Docket Number:	16-BSTD-03
Project Title:	Updates to the 2016 Residential Alternative Calculation Method Reference Manual and Software
TN #:	211216
Document Title:	California Utilities Statewide Codes and Standards Team Comments: On Solar PV Modeling Procedure
Description:	Comments on Draft Title 24 Residential Alternative Calculation Method (ACM) Solar PV Modeling Procedure
Filer:	System
Organization:	Statewide Utility Codes and Standards Team
Submitter Role:	Public
Submission Date:	4/22/2016 5:02:03 PM
Docketed Date:	4/25/2016

Statewide Utility C&S Team - Comments on Solar PV Modeling Procedure

Comments on Draft Title 24 Residential Alternative Calculation Method (ACM) Solar PV Modeling Procedure

California Utilities Statewide Codes and Standards Team

Figure 1: Specific Annual PV Production for Varying Azimuths and Tilts – Climate Zone 12

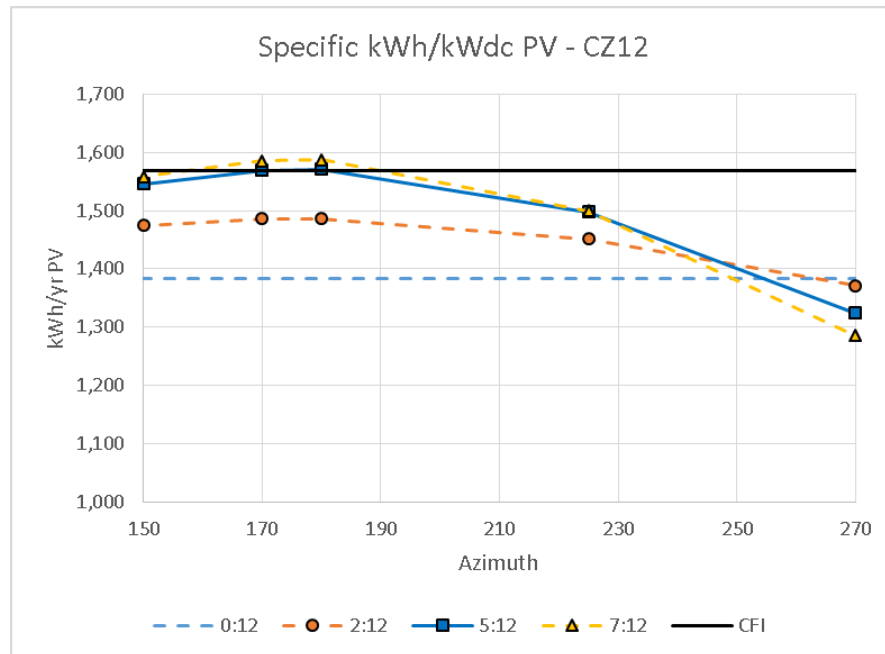
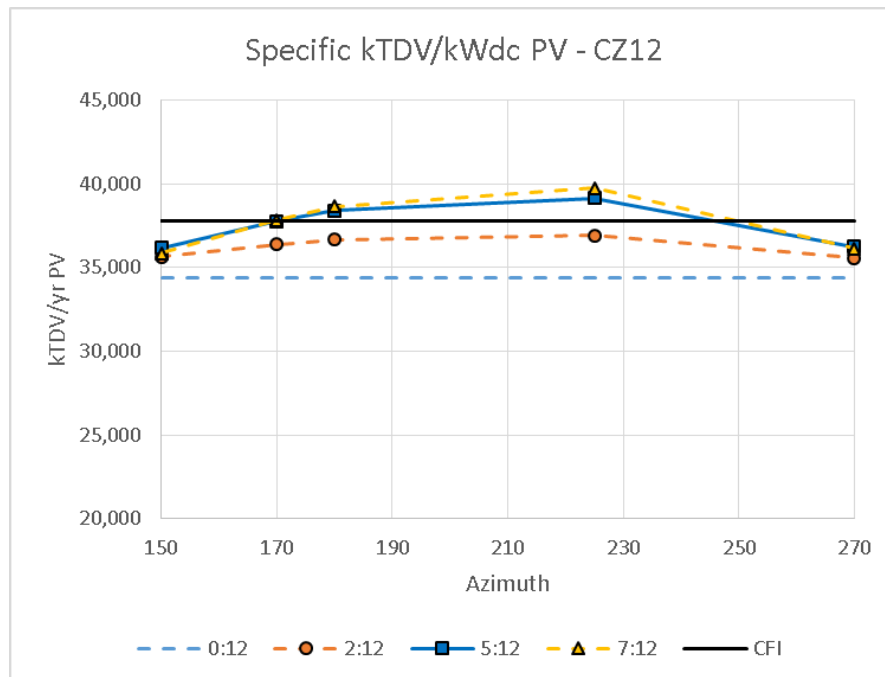
When the CFI option is selected in CBECC-Res, actual production will differ from results using actual azimuth and tilt of the installed PV systems. Table 2, Figure 1 and Figure 2 summarize the variance in performance within the CFI range for Climate Zone 12. The specific annual kWh value for the CFI assumption is close to the maximum specific site kWh production within the CFI range, but closer to the mid-range of specific TDV values.

With the exception of Climate Zones 1, 11, and 16, the percent difference between the CFI values and actual is within 10%. The largest difference in PV production is with flat arrays that are typically at least 9% lower than the CFI values for that climate. In Climate Zone 12, production from a flat array (0:12 tilt) is 9.1% less than the calculated value and production from an array at 7:12 pitch and 225 degree azimuth is 5.2% higher annual TDV (see

If a 5 kW PV system is installed at a 0:12 tilt and the system is run using the CFI calculation, that system would underestimate TDV production by an equivalent of 500W of installed PV.

- Revise the CFI range to be used to between 2:12 and 7:12. This will reduce the percent variance closer to 5% within the azimuth range of 150 to 270 degrees. Flat installations result in the highest reduction in TDV production and do not vary by azimuth. It is recommended that they be run outside CFI.

Figure 3: Comparison of PVWatts and CBECC-Res 2016

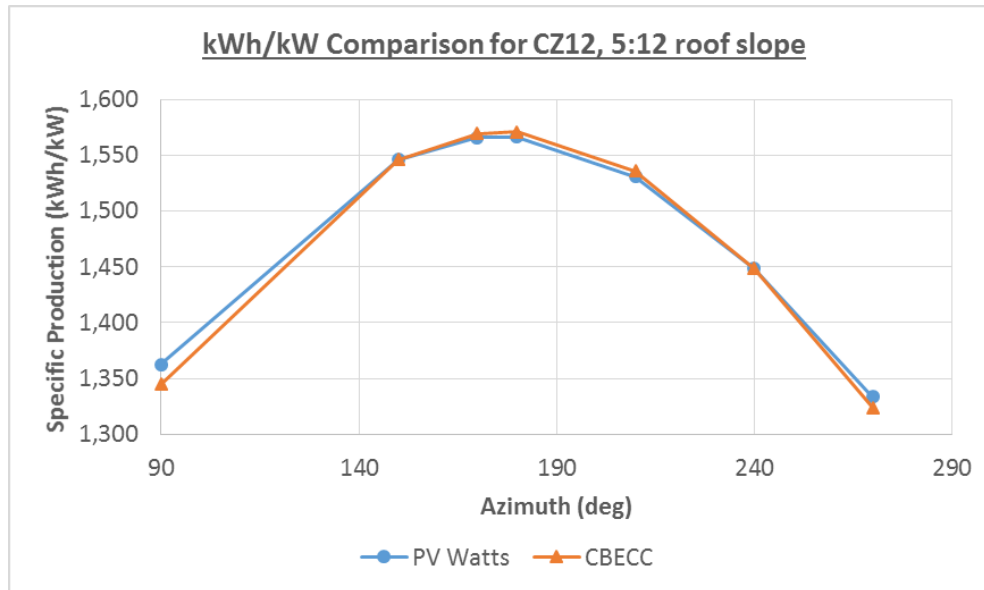
Figure 3 compares the CBECC-Res with PVWatts results. The two models predict similar specific production values at various azimuths. The variance in specific production is highest at 90 degree azimuth (1.3% lower in CBECC), but mostly less than a 1% variance. This isn't a significant value, and at the high end would result in a difference of ~65 Watts for a 5 kW system. Without knowing what assumptions CBECC-Res uses for the DC-to-AC ratio and System Losses, it is impossible to know the source of the differences.

Design Rating Tab

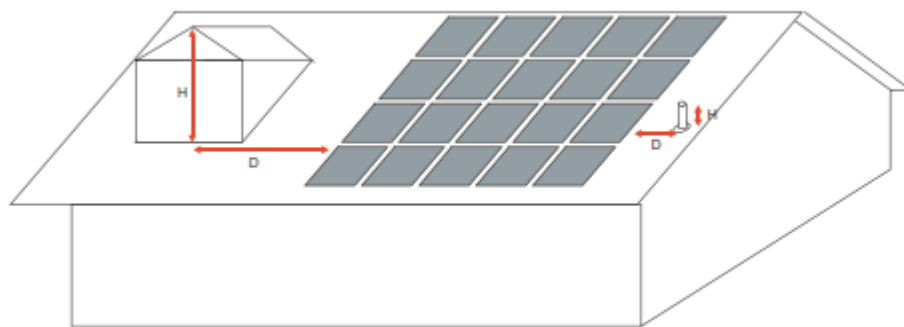
- Provide more information on the Design Rating tab. The limited values don't provide a lot of context.
- Should non regulated load breakdown be in a separate results table under Design Rating? Having these values reported is very useful but is confusing when reported with compliance credit values.
- Add PV TDV production value on this tab. When multiple PV arrays are entered, reporting the TDV production value for each unique array along with total would be beneficial.
